NMISA Building 4W Clean room site assessment and recommendation report

This report provides a summary of the **findings, and recommendations** arising from the assessment of the controlled environment.

Figure 5: Supply grill inside cleanroom showing air leakage on the sides

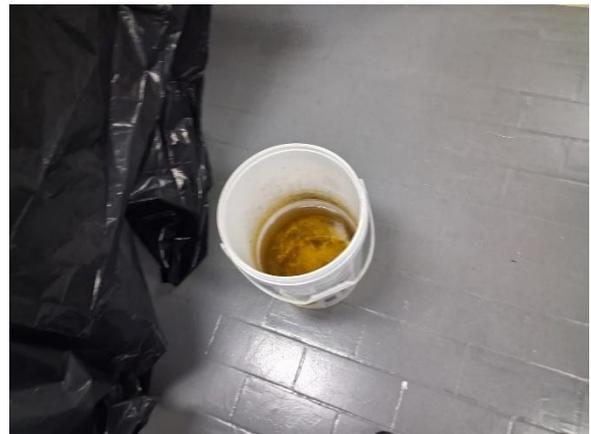
Figure 5: Supply grille inside cleanroom showing air leakage on sides

Air leakage around supply grilles indicates improper sealing and installation. This results in uncontrolled airflow paths, turbulence, and potential particulate ingress, undermining cleanroom classification and pressure control requirements.

Figure 9: Wall not in good condition for cleanroom standard

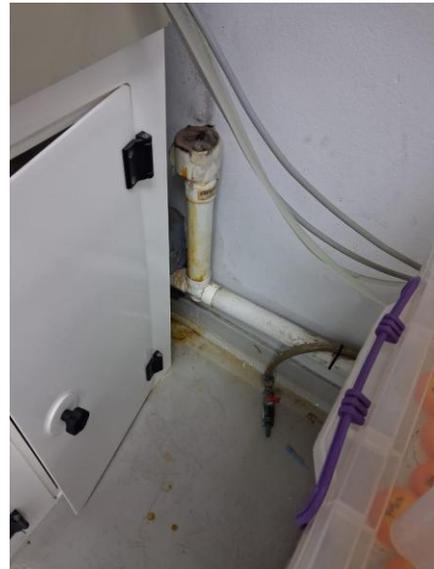
Figure 9: Wall finishes not compliant with cleanroom standards

Cleanroom walls must be smooth, impervious, non-shedding, and easy to clean. Damaged or uneven wall surfaces create contamination traps and are not compliant with ISO 14644 and GMP facility design requirements.

Figure 23: AHU distribution board

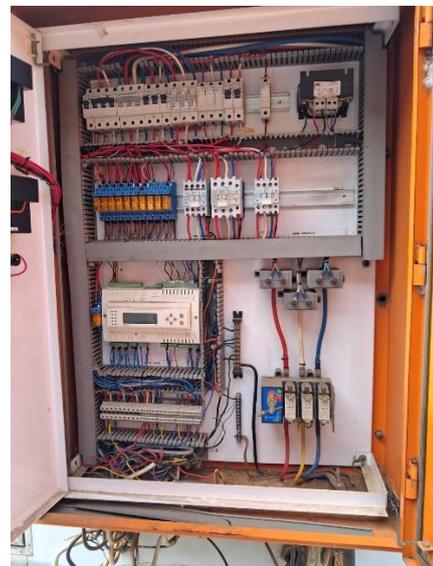
Figure 23 & 24: AHU control panel

Control panels are required to provide clear operational status indication and functional alarms to ensure effective control of cleanroom environmental conditions in accordance with ISO 14644. During the inspection, the control panel was found to be non-functional. The associated distribution box was observed to be in poor condition, with unsafe and poorly arranged wiring, presenting both operational and safety concerns. In addition, the voltage and amperage meters were not functioning, preventing effective monitoring of electrical and system performance. These deficiencies significantly reduce the ability to maintain and verify controlled environmental conditions within the cleanroom.

Figure 27: AHU doors showing leakage

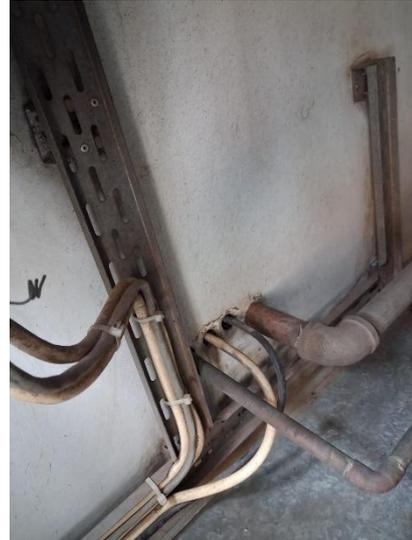
Figure 27 and 28: AHU doors showing air leakage

AHU casings are required to be airtight to prevent bypass air and to maintain filtration integrity. Air leakage was observed at the AHU access doors, reducing system efficiency and allowing unfiltered air to enter the supply air stream. In addition, unsealed penetrations were identified within the AHU casing, providing further pathways for air leakage and contamination. These conditions compromise pressure control and filtration effectiveness, in violation of ISO 14644 system integrity requirements. Furthermore, visible water marks were noted on and around the access doors, indicating previous or ongoing water ingress, which presents a risk of corrosion, microbial growth, and degradation of internal components, further impacting HVAC performance and cleanroom compliance.

Figure 35: Graph showing the pressures with all fume hoods not in operation

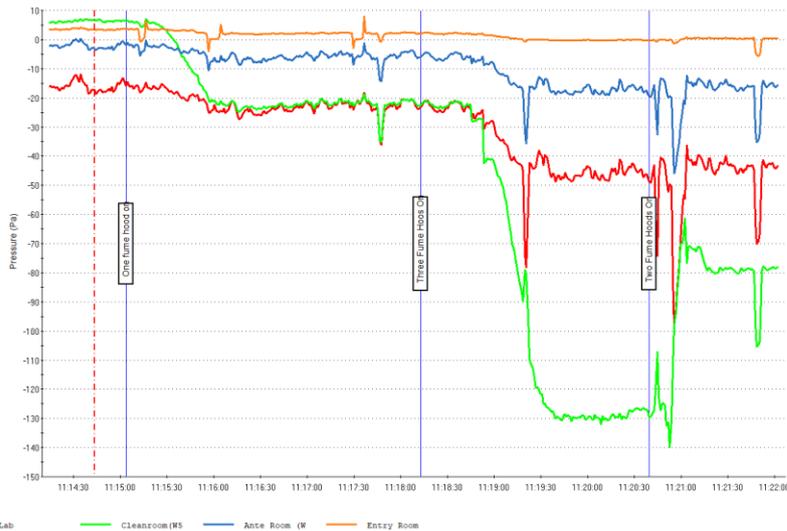
At the start of the monitoring period, all the fume hoods were switched off, with the Entry Room remaining slightly positive, the Ante Room operating at a moderate negative pressure, and the Cleanroom and Laboratory operating at more negative pressures relative to adjacent spaces. Minor fluctuations are observed, consistent with normal operational variability.

Figure 37: Graph showing the pressures with two fume hoods running

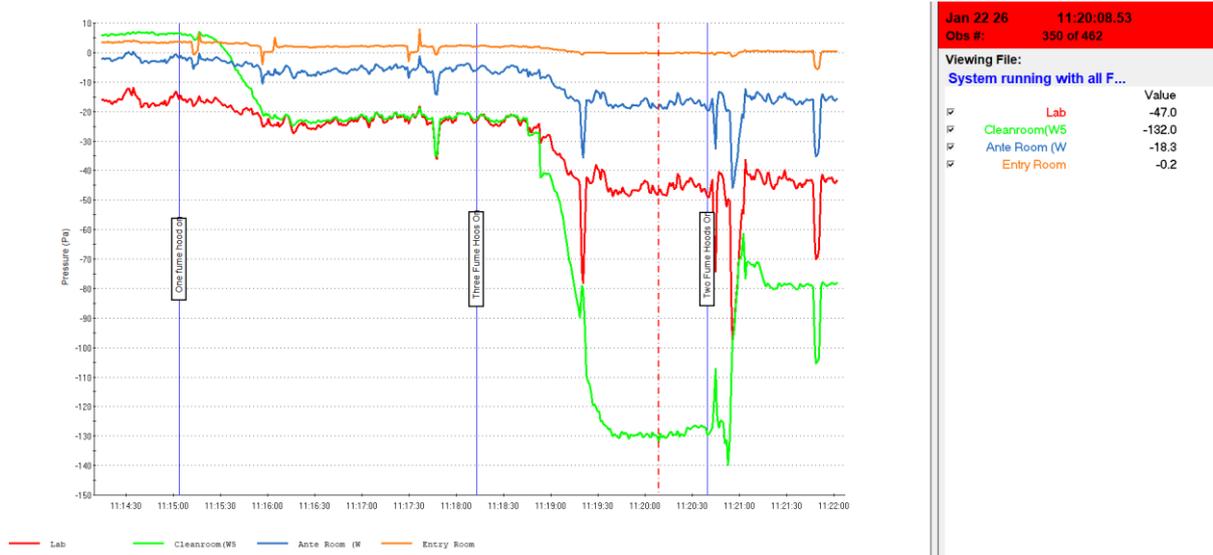
The most severe pressure fluctuations were observed when three fume hoods were operated simultaneously. During this condition, rapid pressure drops and recoveries occurred, indicating instability within the HVAC control system and a limited ability to respond dynamically to increased exhaust demand.

Figure 38: Graph showing the pressures with three fume hoods running

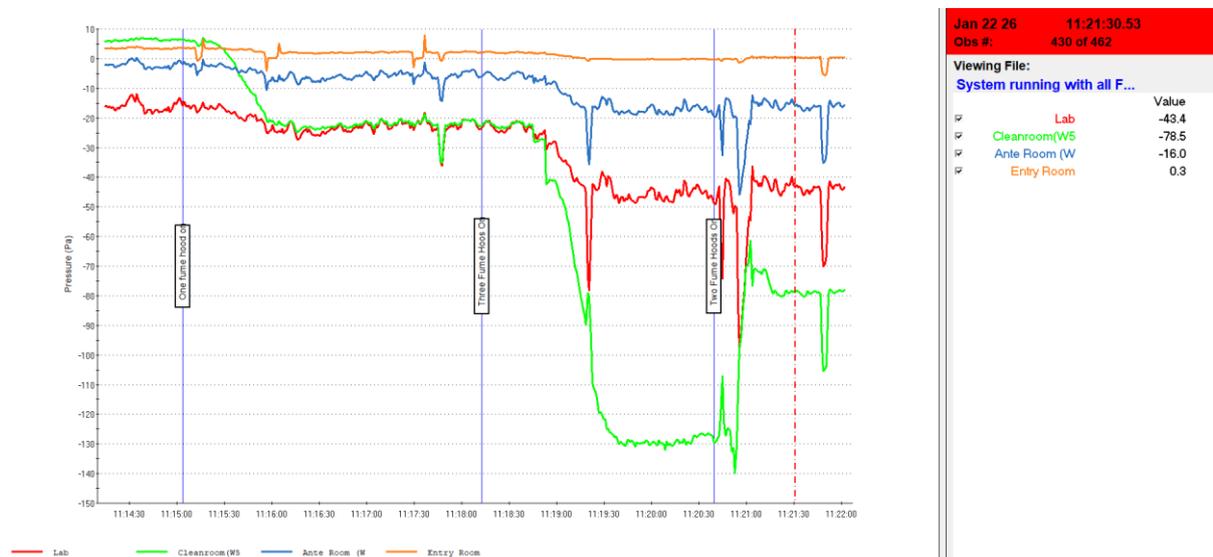
After observing the pressures when the 3 fume hoods are running, it was noted that this scenario resulted in a significant drop in pressure in the cleanroom, we therefore switched off one fume hood to observe the impact this would have on the system. After switching off one fume hood to have 2 fume hoods running, we noted a slight increase in pressure which still results in a negative pressure state of the cleanroom. This behaviour indicates that the combined exhaust demand from the fume hoods exceeds the available supply air capacity, resulting in excessive depressurisation of the controlled spaces. The Cleanroom becoming increasingly negative represents a deviation from the

intended pressure cascade and poses a risk to contamination control and ISO 14644 and GMP compliance

Airflow Schematic Current Operating Condition

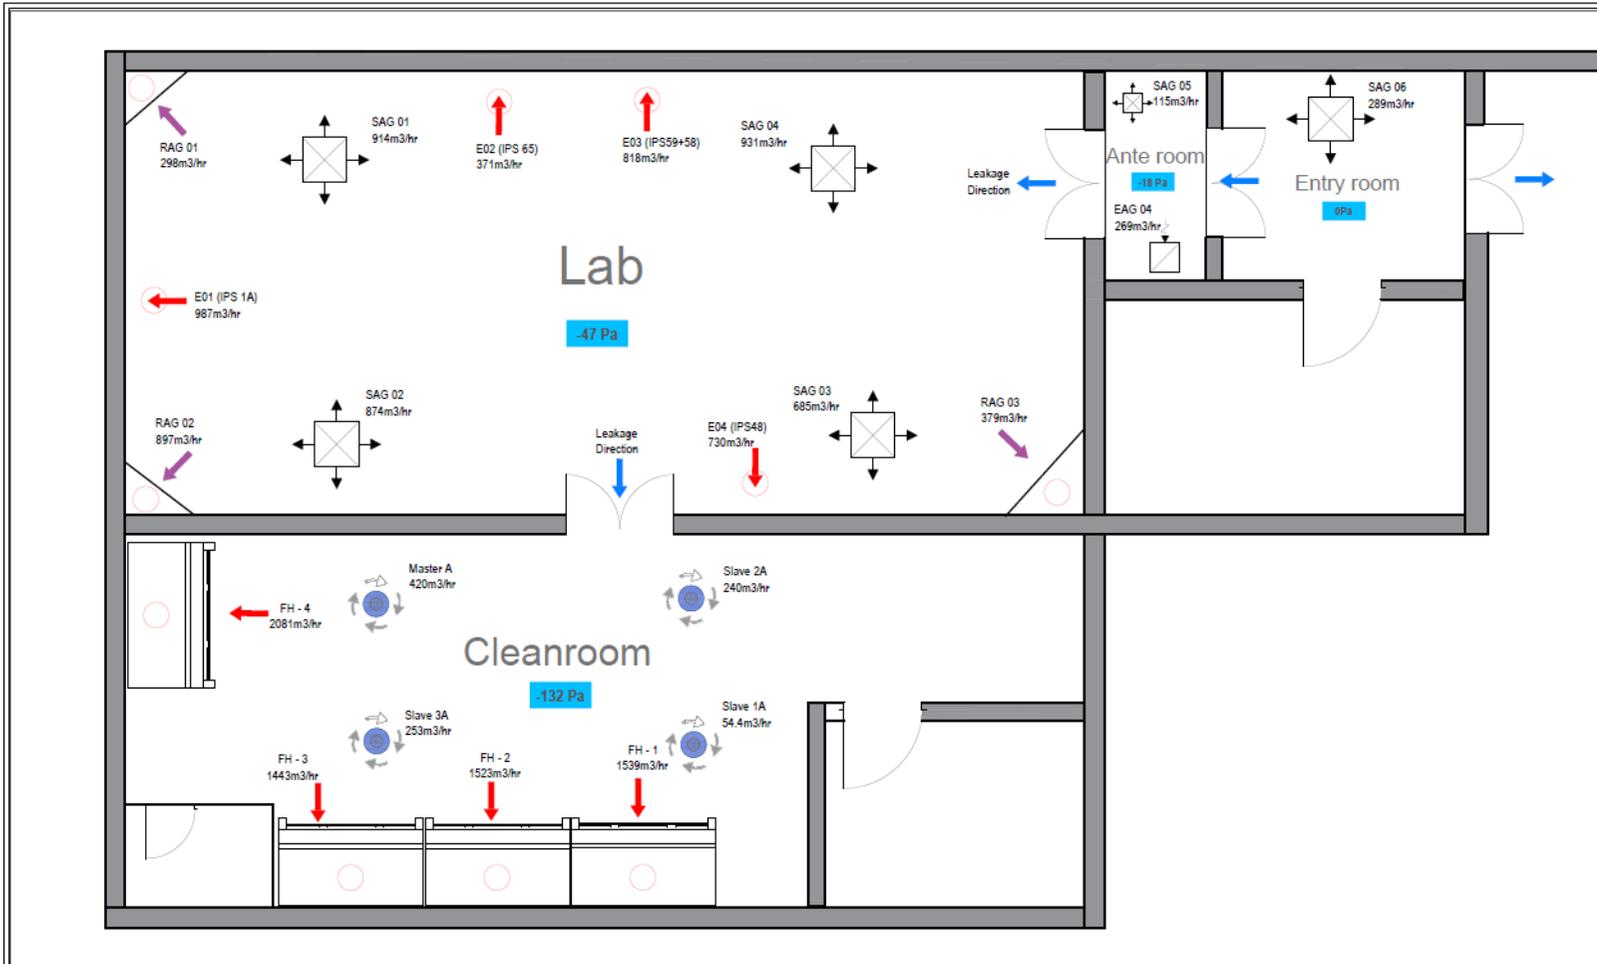
The above airflow schematic illustrates the current operating condition of the cleanroom, laboratory, ante room, and entry room as assessed during the site inspection and performance testing. The schematic presents the measured supply, return, and exhaust airflow rates, together with the corresponding room pressures recorded **while fume hoods FH-1, FH-3, and FH-4 were in operation**.

As shown on the schematic, the Entry Room is maintained at approximately 0 Pa, while the Ante Room operates at approximately -18 Pa. The Laboratory and Cleanroom, however, are operating at significantly negative pressures of approximately -47 Pa and -132 Pa respectively under this operating scenario. This pressure regime indicates a loss of the intended pressure cascade, with the Cleanroom being the most negatively pressurised space, which is not aligned with ISO 14644 and GMP cleanroom design principles.

The Cleanroom is served by multiple fume hoods, and the combined exhaust demand from **fume hoods FH-1, FH-3, and FH-4** exceeds the supply air delivered to the space. This results in severe depressurisation of the Cleanroom, as evidenced by the measured room pressure and the airflow leakage paths indicated at door interfaces and envelope penetrations. Airflow arrows on the schematic confirm that air is being drawn from adjacent areas, including the Laboratory and Ante Room, into the Cleanroom to compensate for the shortfall in supply air.

The Laboratory is similarly affected, operating under negative pressure due to a combination of exhaust airflows and insufficient supply compensation. Although supply and return air grilles are present, the measured airflow rates are inadequate to counterbalance the exhaust demand and envelope leakage, resulting in uncontrolled airflow paths and pressure instability.

The Ante Room, intended to function as a pressure buffer between the Entry Room and the controlled spaces, is unable to maintain effective pressure stabilisation due to the magnitude of the negative pressures generated downstream during fume hood operation. This increases the risk of airflow reversal and compromises contamination control.

Overall, the airflow schematic demonstrates that, under the tested operating condition with fume hoods FH-1, FH-3, and FH-4 in operation, the existing HVAC system is unable to maintain stable airflow balance and pressure differentials. This finding directly supports the conclusions drawn from the pressure trend analysis and confirms the need for system upgrades to achieve compliance with ISO 14644 and GMP requirements.

Based on the results of the worst-case testing, it is recommended that the existing AHU be replaced with a suitably sized and controlled unit designed to meet the full supply air demand under maximum exhaust loading. The replacement AHU shall be capable of maintaining stable airflow rates and pressure differentials in accordance with ISO 14644 and GMP requirements during all operating conditions.
